RIVER DISTRICT DESIGN COMMISSION REGULAR MEETING AGENDA

DATE: August 8, 2024
TO: River District Design Commission
FROM: Renee Burton, Division Director of Planning
RE: Certificate of Appropriateness applicaiton PZ24-00378 filed by Hampton Wilkins to install privacy fence in side yard at 515 Memorial Drive (Parcel 23779).

CERTIFICATE OF APPROPRIATENESS APPLICATION

Street view

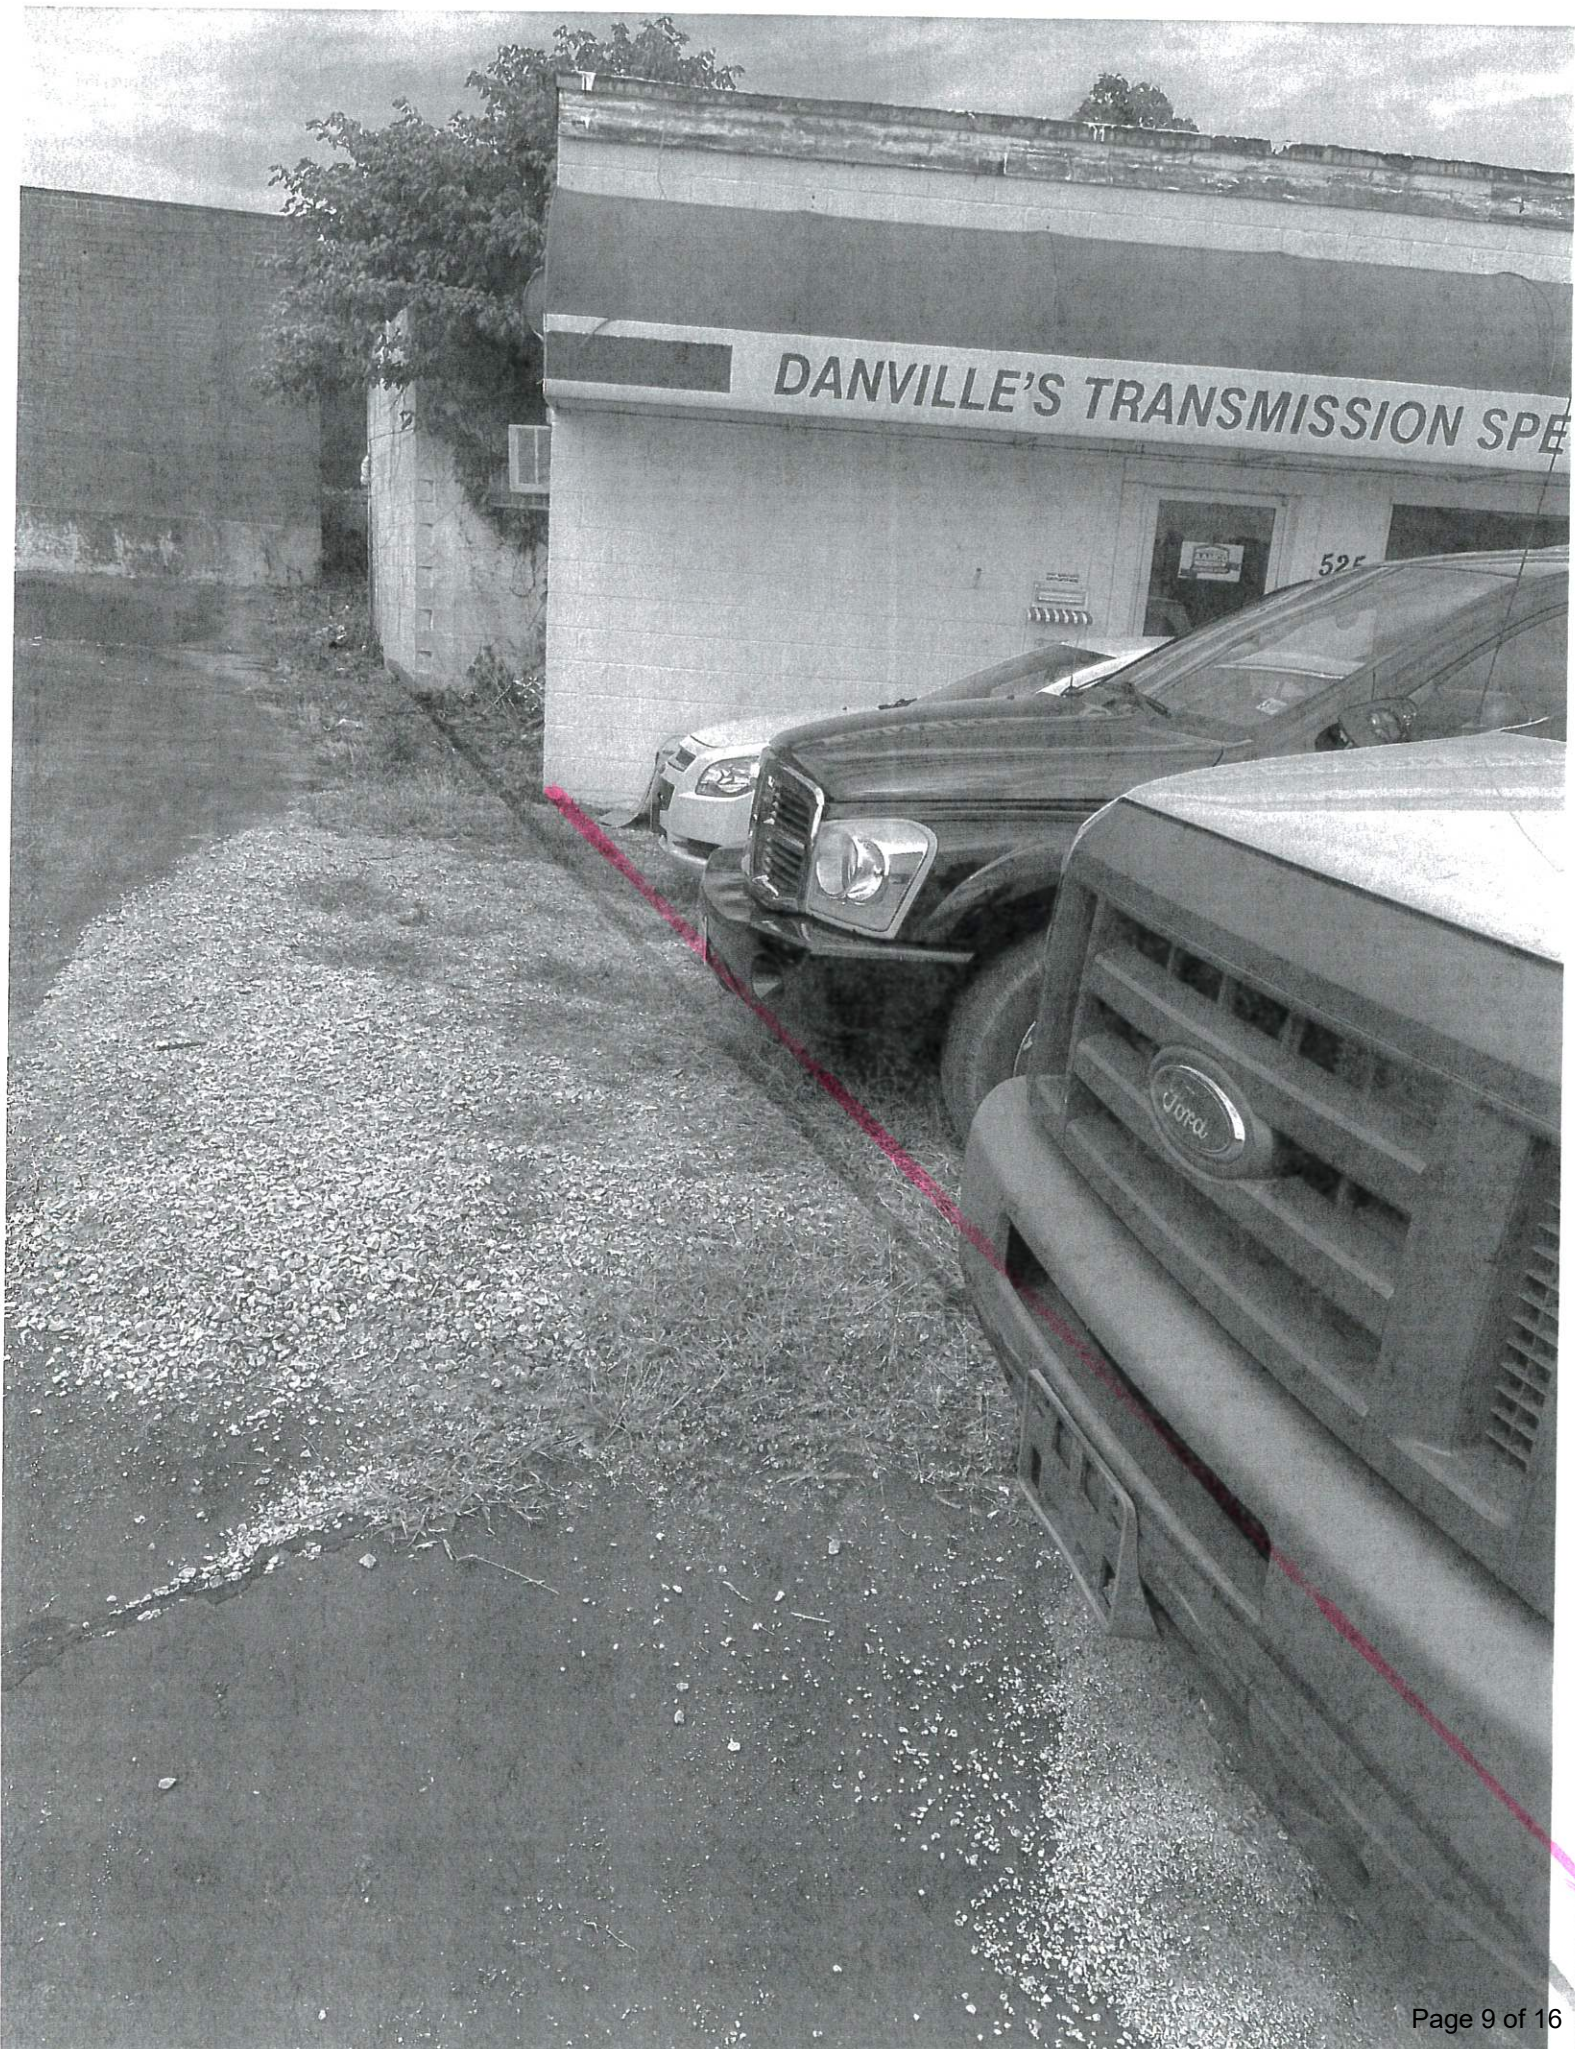
The applicant, Hampton Wilkins, is requesting to install a privacy fence on the property line between 515 and 525 Memorial Drive to prevent vehicles parked at the neighboring auto repair facility from encroaching on the property. The applicant proposes a 54-inch tall horizontal wooden fence that will run from the rear to the front.

The corner of Memorial Drive and Poplar Street is a highly visible location in a high traffic area. The height and the aesthetic of the fence must be considered. The proposed fencing, height and location, may present an obstruction to vision for vehicle and pedestrian travel on Memorial Drive and Poplar Street.

The Planning Staff acknowledges the potential dangers for both pedestrians and vehicles in the current parking situation at 525 Memorial Drive. However, staff has also noted that the proposed fence, as submitted, could obstruct visibility in a high-traffic area. Therefore, staff recommends approval of PZ24-00378 to construct a horizontal wood slat fence with the following conditions:

1. The fence may not exceed four (4) feet in height for a minimum of ten (10) foot setback from the back of the sidewalk (r-o-w) toward the structure along the northwest property

line of 515 Memorial Drive.

2. The fence may not exceed six (6) feet in height from a ten (10) foot setback from the r-o-w towards the rear property line along the northwest property line of 515 Memorial Drive.
3. The fence must be constructed so that the finished side or face of the fence is towards 525 Memorial Drive.
4. The fence must be constructed so that the unfinished or back of the fence that is towards 515 Memorial Drive must be landscaped. If the fence is constructed so that both sides are finished, no additional landscaping is required.
